# UNITED STATES PATENT AND TRADEMARK OFFICE

APPLICATION NO.	FILING DATE	FIRST NAMED INVENTOR	ATTORNEY DOCKET NO.	CONFIRMATION NO.
10/707,539	12/19/2003	Markus Reiter	20072	1538
23470	7590	12/12/2006	EXAMINER	
SRAM CORPORATION				CHARLES, MARCUS
1333 N. KINGSBURY, 4TH FLOOR				ART UNIT
CHICAGO, IL 60622				PAPER NUMBER
				3682

<b>Office Action Summary</b>	<b>Application No.</b>	<b>Applicant(s)</b>
	10/707,539	REITER, MARKUS
Examiner	Art Unit	
Marcus Charles	3682

This is the first action relating to serial application number 10/707,539 filed 12-19-2003. Claims 1-25 are currently pending.

FIG. 2

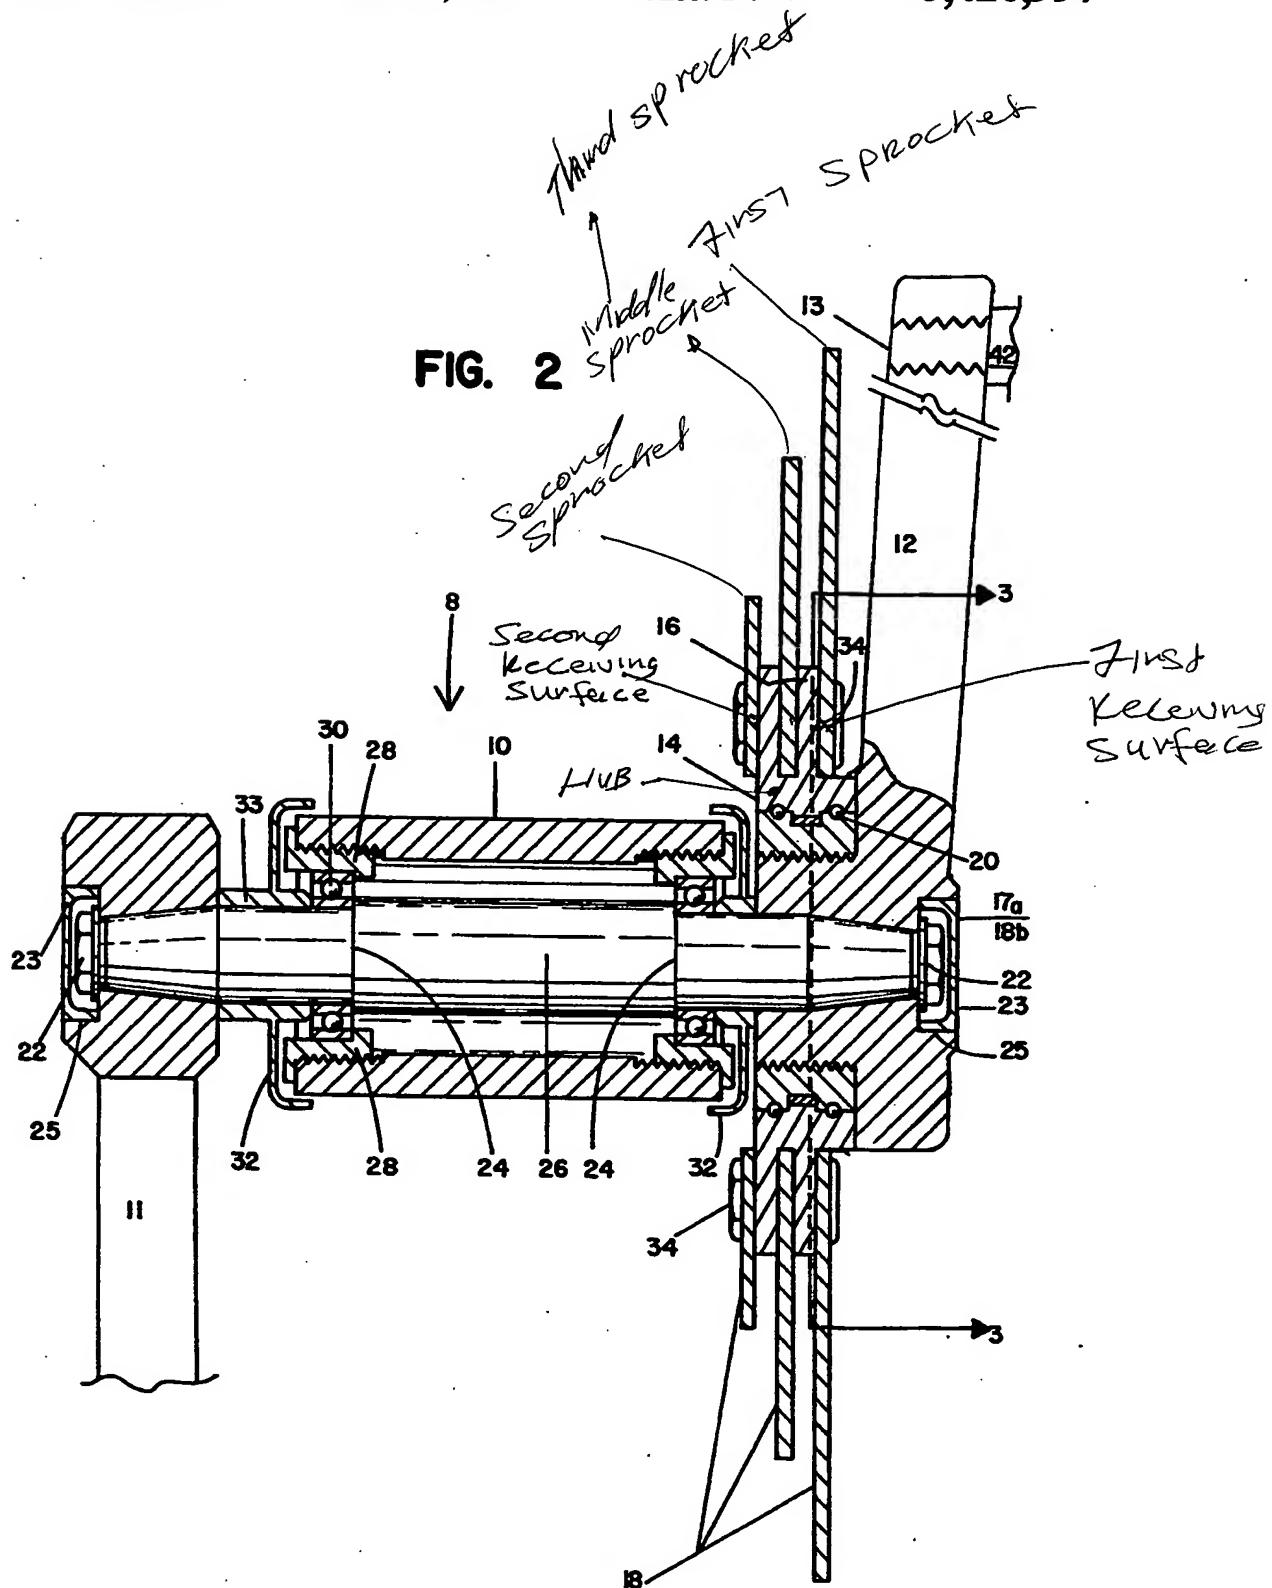
9. Claim 3 is rejected under 35 U.S.C. 103(a) as being unpatentable over Brion in view of Yang (5,782,713). Brion fails to disclose the sprocket includes a plurality of mounting tabs. Yang discloses a plurality of sprockets having a plurality of radially extending tabs (see attached illustration of fig. 1). Therefore, it would have been obvious to one of ordinary skill in the art at the time of the invention to modify the sprockets of Brion so as to include radially extending tabs as shown by Yang in order to increase the weights of the sprocket and to properly align the sprocket with the mounting holes of the hub.
